DEVELOPMENT APPLICATION ASSESSMENT REPORT

Application Number:	DA2019/0092	
Responsible Officer:	Catriona Shirley	
Land to be developed (Address):	Lot 20 DP 16081, 30 Lancaster Crescent COLLAROY NSW 2097	
Proposed Development:	Alterations and additions to a dwelling house including conversion of an existing garage into secondary dwelling	
Zoning:	Warringah LEP2011 - Land zoned R2 Low Density Residential	
Development Permissible:	Yes	
Existing Use Rights:	No	
Consent Authority:	Northern Beaches Council	
Land and Environment Court Action:	No	
Owner:	Christopher James Kelly Susan Elizabeth Kelly	
Applicant:	Christopher James Kelly	
Application lodged:	06/02/2019	
Integrated Development:	No	
Designated Development:	No	
State Reporting Category:	Residential - New second occupancy	
Notified:	18/02/2019 to 06/03/2019	
Advertised:	Not Advertised	
Submissions Received:	2	
Recommendation:	Approval	
Estimated Cost of Works:	\$ 488,500.00

Figure 4. Large stairwell window

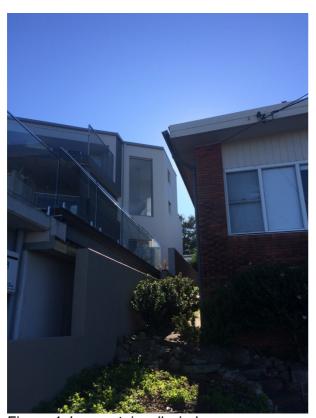
The affected views from the large stairwell window are the most affected to the south-east and consists of a views that sweep uninterruptedly (with the exception of the roofline of 30 Lancaster) from the south-east, and south.

The views are obtained from both a standing and sitting position within the stairwell. However, this area is a transitional area for access between the mid and upper floor levels, therefore this is not an area sitting would be undertaken. The most affected area is the first landing area as you transition to the upper floor. The affected views from the proposal within this area will be of the Dee Why Headland, the wave zone and Dee Why Lagoon. As you move up the access stairs the view impact changes to impacts on Dee Why Lagoon only. The headland, and Dee Why beach views are unaffected by the proposal within this area.

The extent of impact is considered to be moderate.

Figure 7. Adjoining eastern site.

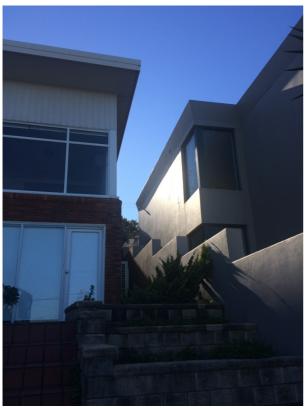
The additional windows on the eastern elevation will overlook the roof line of the eastern neighbouring house. Therefore, no mitigation measures are required for this area.
